# COUNTY COUNCIL'S RESPONSE TO CONSULTATION ON THE FOLLOWING DEVELOPMENT PROPOSAL

**Application no:** 24/02514/OUT

**Proposal:** Outline planning application for up to 114 dwellings and associated open space with all matters reserved other than access - re-submission of 23/03366/OUT

**Location:** Land Opposite Hanwell Fields Recreation Adj To, Dukes Meadow Drive, Banbury

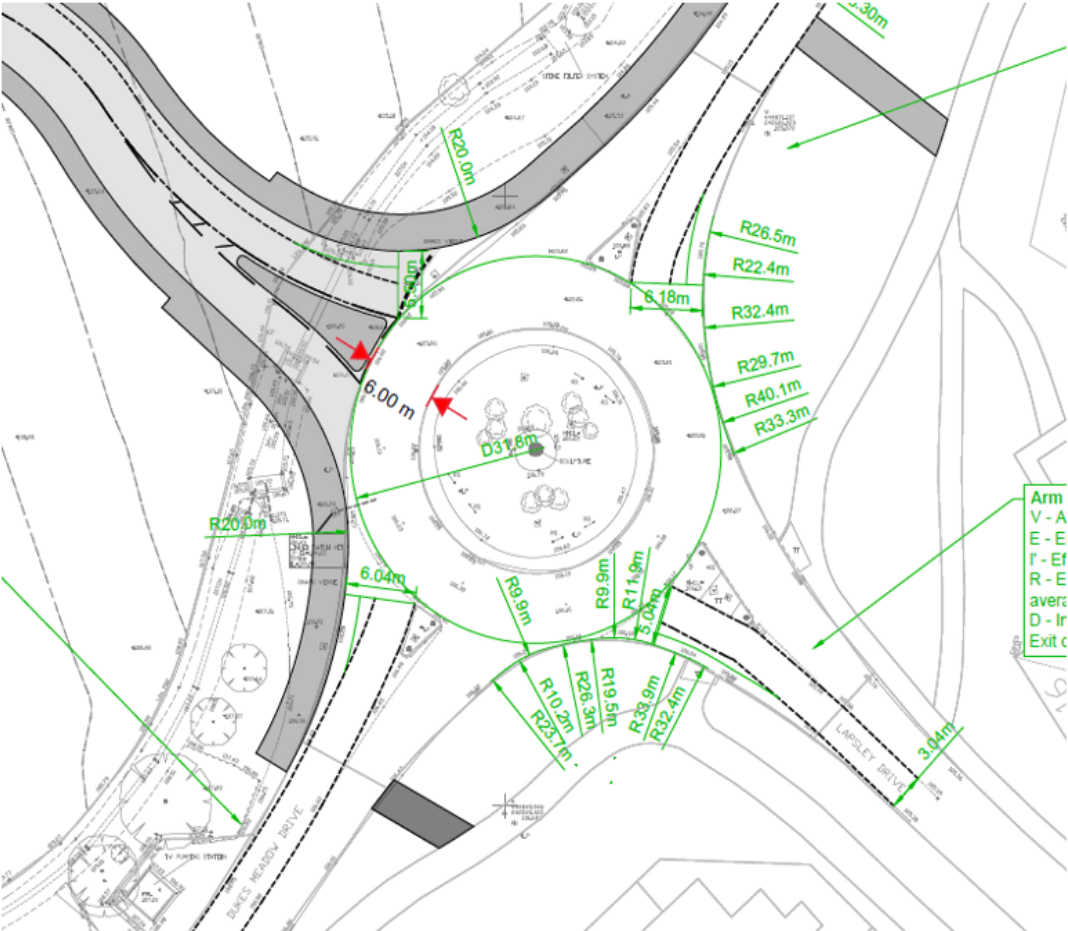
Further clarification (below) is required with respect to the roundabout from which the development shall acquire access.

- Is the new roundabout arm serving these developments designed to a Compact or a Normal Roundabout? This will be helpful to know which design criteria we need to review against within CD 116 Geometric design of roundabouts. We have made general comments which cover both roundabout designs.
- Please amend the entry and exit width for the site access in accordance with point 3.6 of CD 116 - *The width of the circulatory carriageway for normal or compact roundabouts shall be between 1.0 and 1.2 times the maximum entry width, excluding*

any overrun area. As shown below the circulatory carriageway width is 6m, so the minimum entry width will need to be 6m. Please amend to the entry width from 5.5m to 6m.

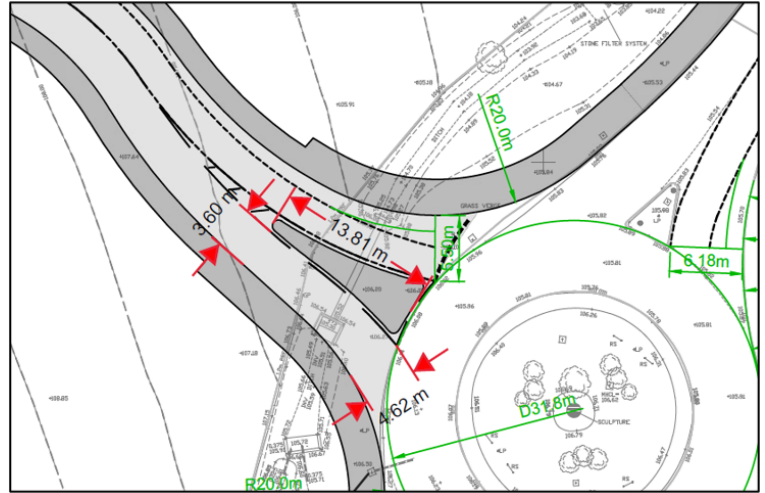
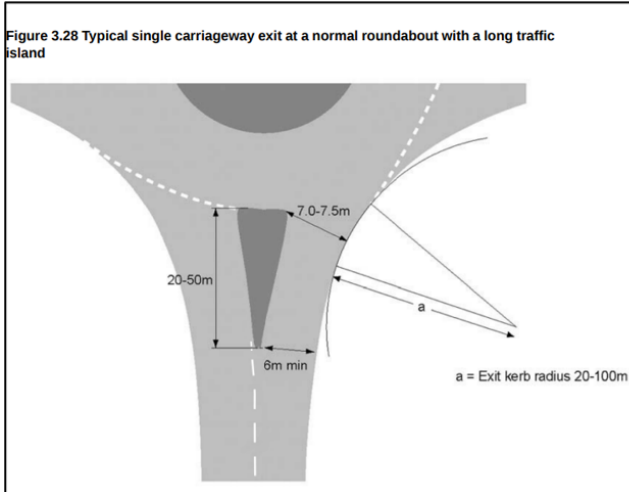
- If the site access is required to have a long traffic island, please can it be designed in accordance with Figure 3.28 in CD 116 as shown below. You can see from the below extract it does not meet the requirements. OCC is happy for the traffic island to be reduced to a similar length as the existing ones, but please ensure the minimum road width is 6m as highlighted below. At a compact roundabout, the exit width should be similar to the entry width.

- There needs to be a crossing facility around the traffic island to enable safe and suitable access from one side of the carriageway to the other across the access arm of the roundabout.

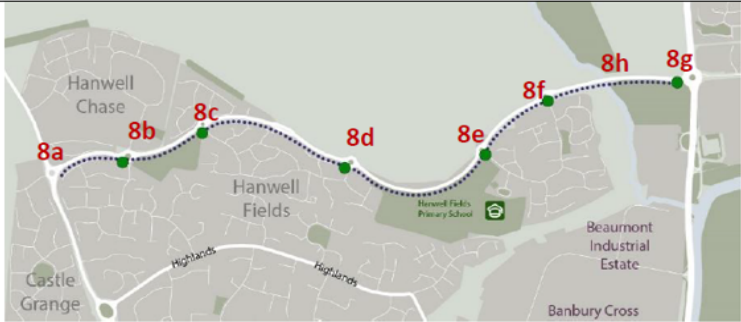
Contributions towards upgrading the current footpath on the southern side of the carriageway to a segregated cycle and footpath in line with the current LTN1/20 guidelines

should be provided from Lapsley drive roundabout to Winter Gardens way roundabout. This will be approximately 500 m of segregated walking and cycling path. Also ensure that there are safe crossings from the development arm of the roundabout to the Lapsley drive, to ensure residents can cross into the Hanwell Fields Shops, schools and community centre safely.
